### **ADDENDUM NO. 3**

**RE:           UNC-CH Coastal Process Environmental Health Lab**  
SCO ID No: 23-26296-01A  
McKim & Creed No: 01488-0083

DATE:       October 9, 2024

**2 COOLING TOWER PUMP ROOM 143 - DEMOLITION**  
M1.0 SCALE : 1/4" = 1'-0"

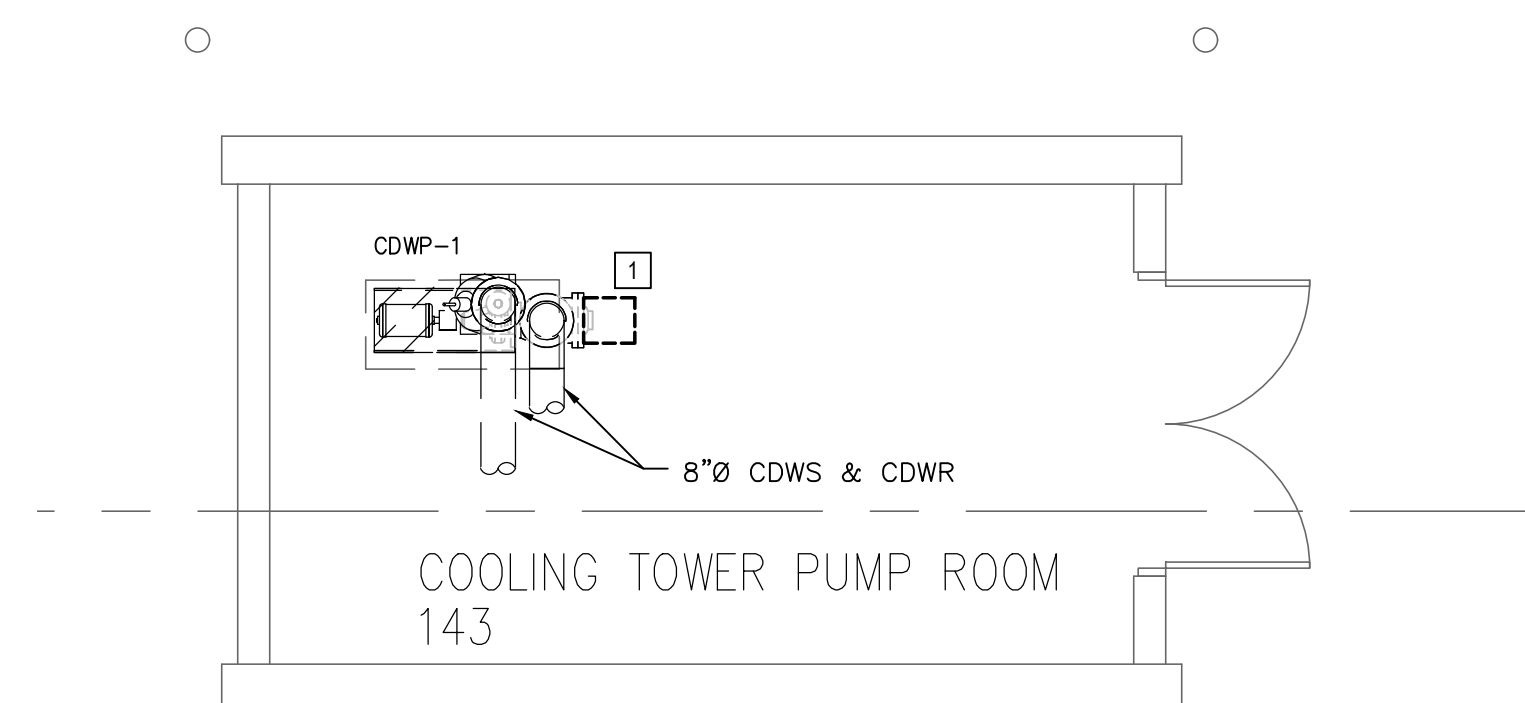
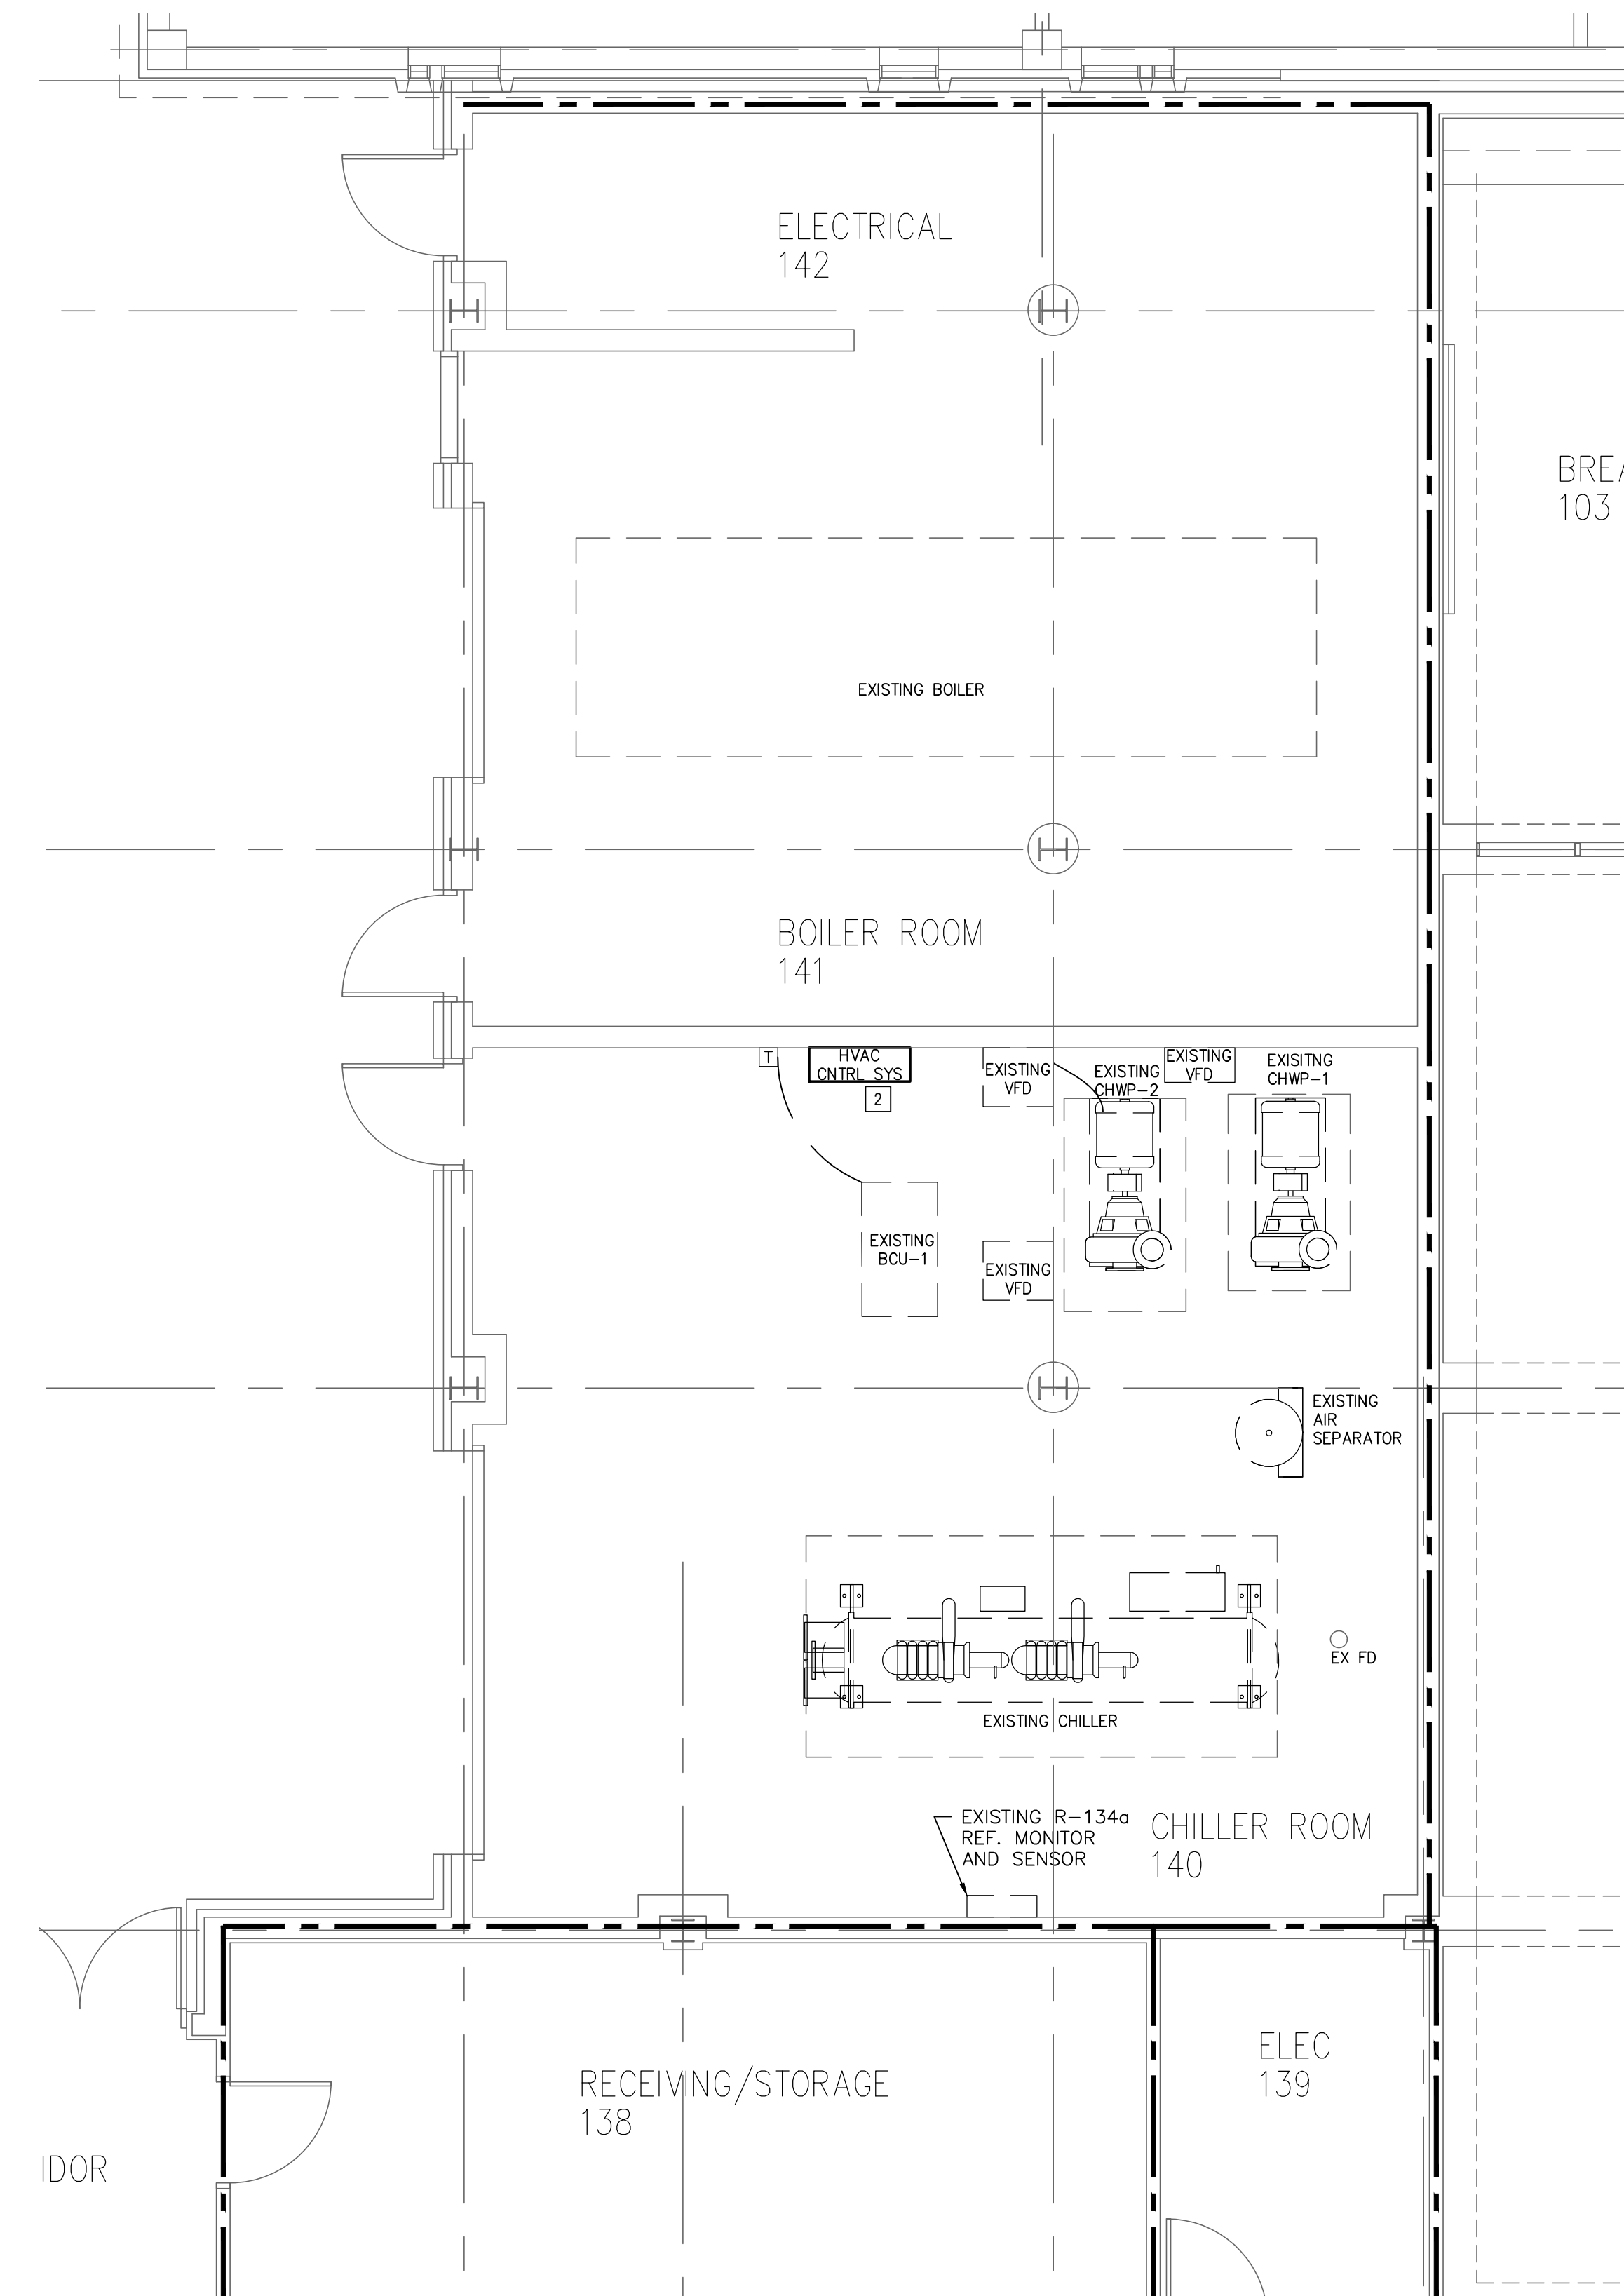
- M1.0 – Mechanical Demolition – Revised to address controls.
- M1.1 – Mechanical New Work – Revised to address controls.
- M4.0 – Mechanical Controls – Revised to address controls.
- Based on removal of Alternate M-02A and M-02B from the Form of Proposal noted above, references to any of these alternates in the drawings shall be deleted.

1. REMOVE EXISTING CONDENSER WATER BYPASS CONTROL VALVE.
2. EXISTING SIEMENS LEGACY DDC CONTROL PANEL. CONTROL PANEL IS NOT CURRENTLY OPERATIONAL. CONTRACTOR SHALL INCLUDE ALLOWANCE TO DIAGNOSE AND REPAIR EXISTING SYSTEM. REFER TO 012100 ALLOWANCES.

**2 | COOLING TOWER PUMP ROOM 143 - NEW WORK**  
M1.1 SCALE : 1/4" = 1'-0"

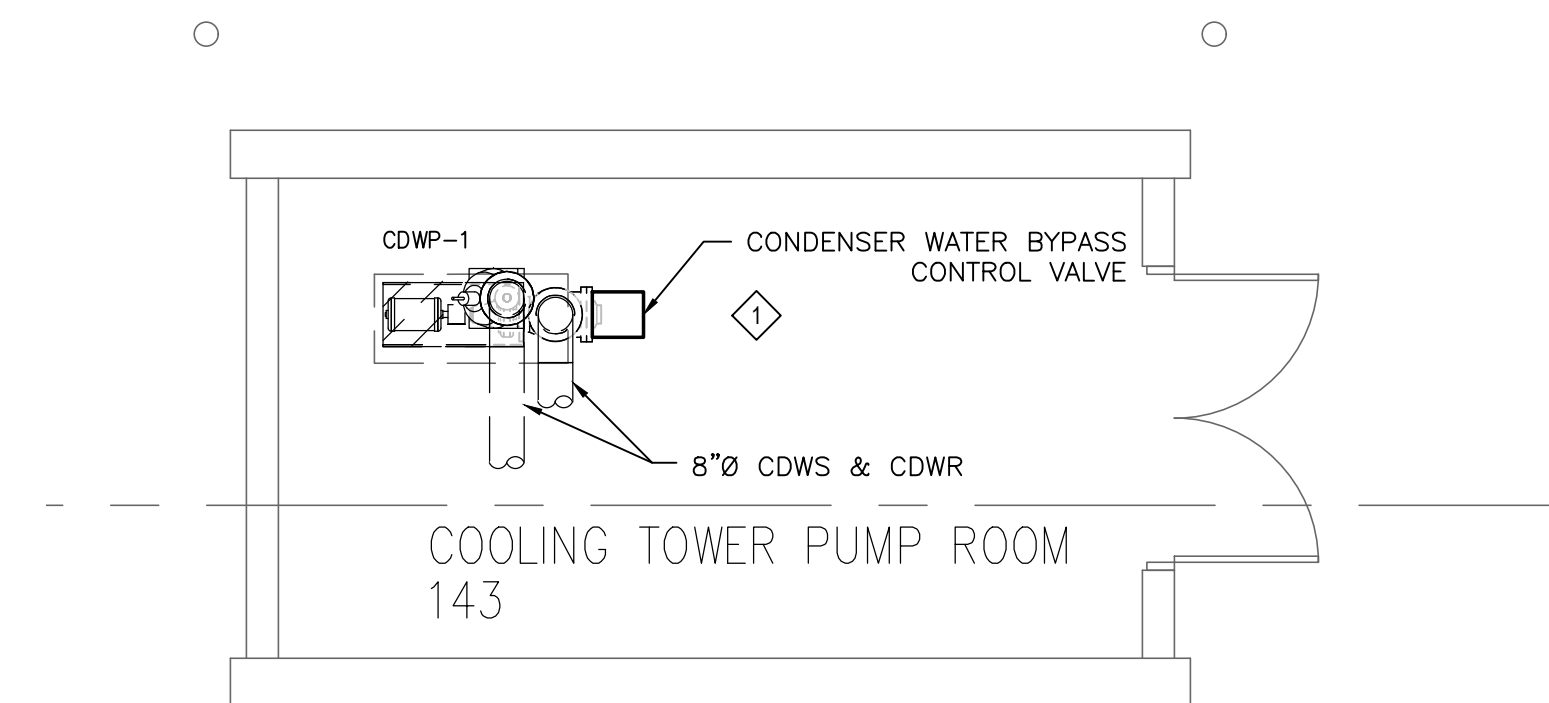
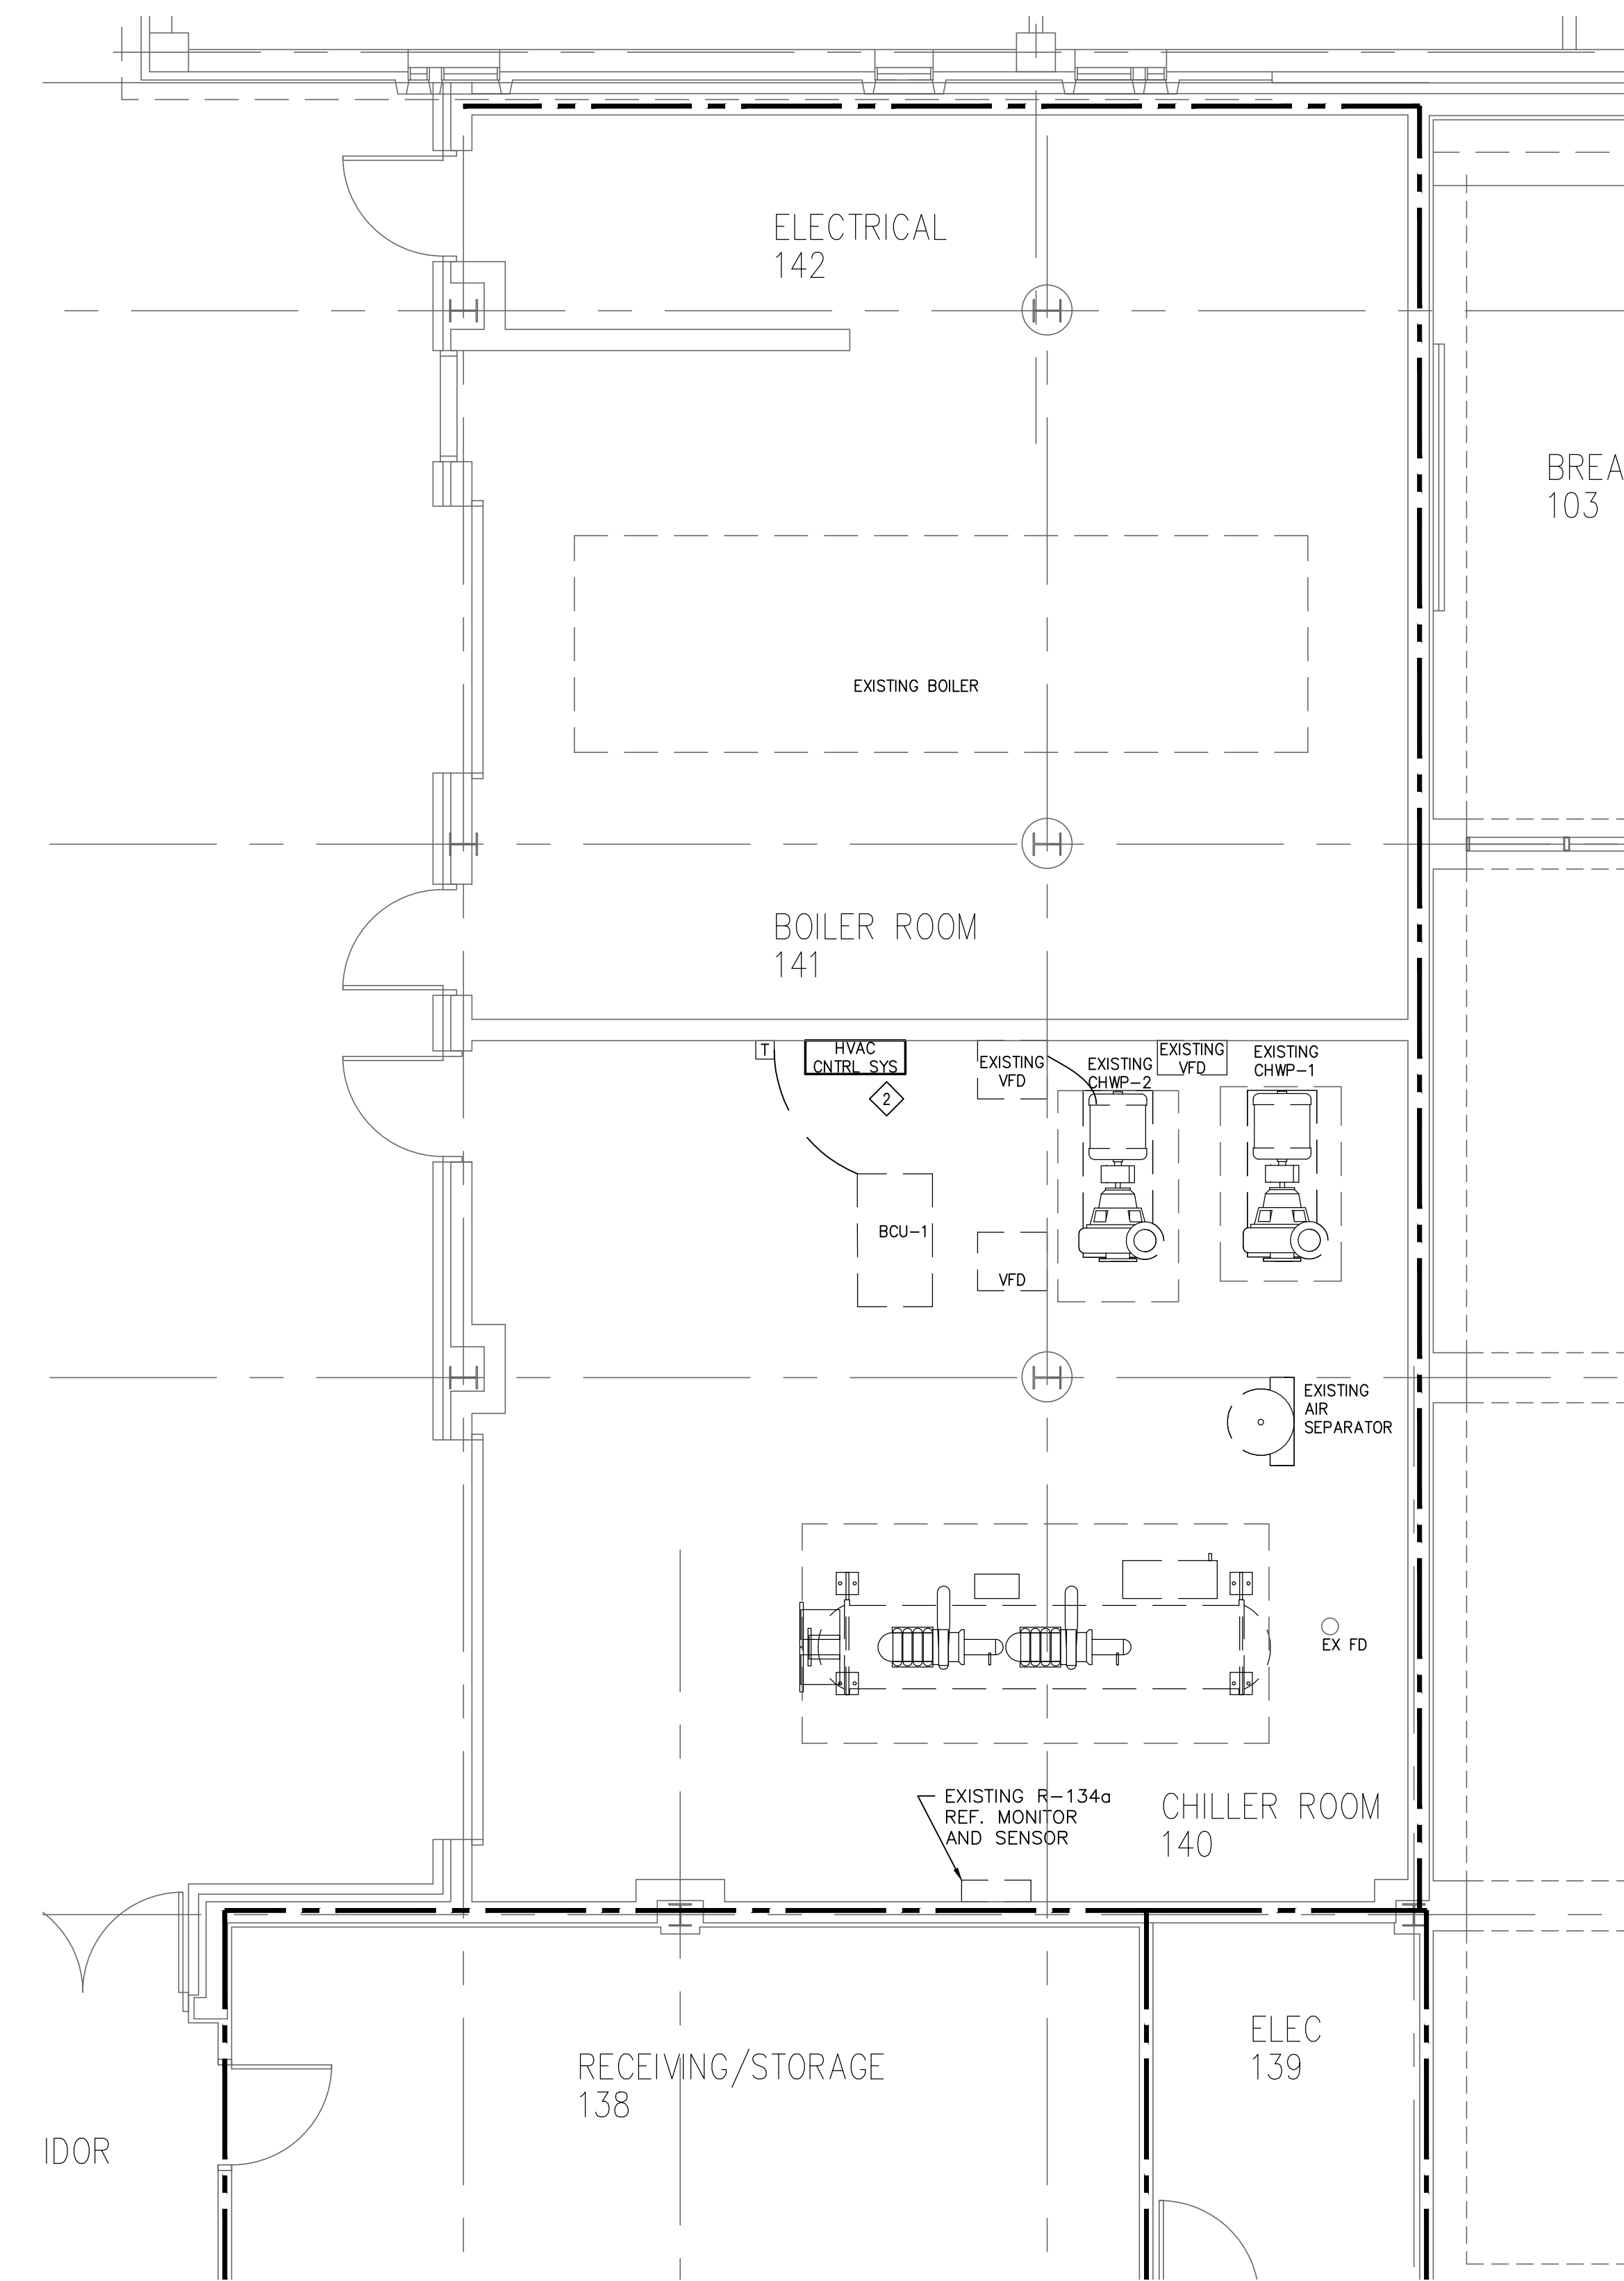
1. PROVIDE NEW 8"Ø CONDENSER WATER BYPASS CONTROL VALVE AT THIS LOCATION. INSTALL PER MANUFACTURERS RECOMMENDATIONS. EXISTING CONTROL SEQUENCE TO REMAIN.
2. EXISTING SIEMENS LEGACY DDC CONTROL PANEL. CONTROL PANEL IS NOT CURRENTLY OPERATIONAL. CONTRACTOR SHALL INCLUDE ALLOWANCE TO DIAGNOSE AND REPAIR EXISTING SYSTEM. REFER TO 012100 ALLOWANCES.
